Portofino Vineyards
Villages of San Carlos Parcels B, C, D & E
ADD2017-00098
Schedule of Deviations and Written Justification
Revised December 13, 2017

TYPICAL LAKE CROSS SECTION
FOR EXISTING LAKES 3, 4 & 5

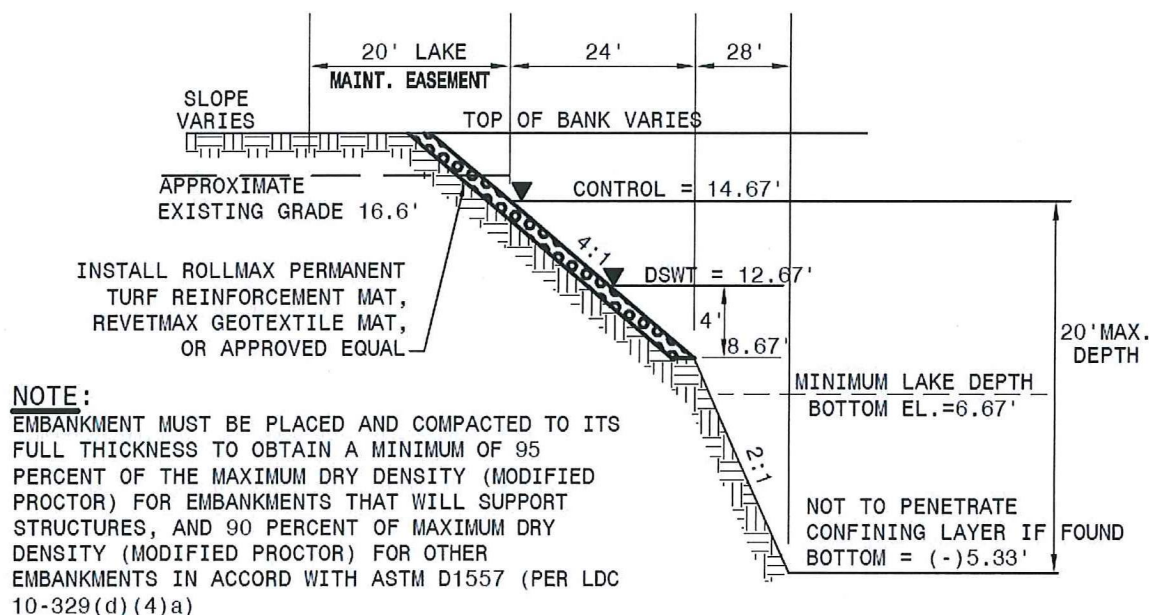
DEVIATION 15: From LDC Section 10-329(d)(4) which requires the banks of excavations to be sloped at a ratio not greater than six horizontal to one vertical; to allow a slope no steeper than four to one for 3 of the existing lakes (lakes 3, 4 & 5 on proposed DO plans) with enhanced slope protection measures by reinforcement per below cross-section and providing double the required littoral plantings as shown on the attached landscape plan.

JUSTIFICATION: The project originally received development order approval on October 29, 2007 pursuant to DOS2006-00115. Upon approval of the D.O. and vegetation removal permit, site construction commenced. Site work was subsequently stopped due to economic conditions. At the time site work was halted, these lakes had

been constructed in compliance with the D.O. approval (see aerial below and lakes labeled 3, 4 & 5). On June 23, 2009, the Land Development Code was amended by Ordinance 09-23 which changed the design standards for new excavation bank slopes from a ratio of four horizontal to one vertical to six horizontal to one vertical. The applicant proposes the following enhanced slope protection measures which will prevent erosion and scouring: enhanced littoral plantings by doubling the required amount in combination with installation of RollMax permanent turf reinforcement mat, RevetMax geotextile mat or approved equal. The proposed littoral planting plan is attached. Administrative deviations for lakes designed and approved by prior development orders have been previously requested and approved from the required six to one slope to allow a slope no steeper than four to one, consistent with the existing approvals and subject request. The alternative proposed is based on sound engineering practices and is no less consistent with the health, safety and welfare of abutting landowners and the general public than the standard from which the deviation is being requested.
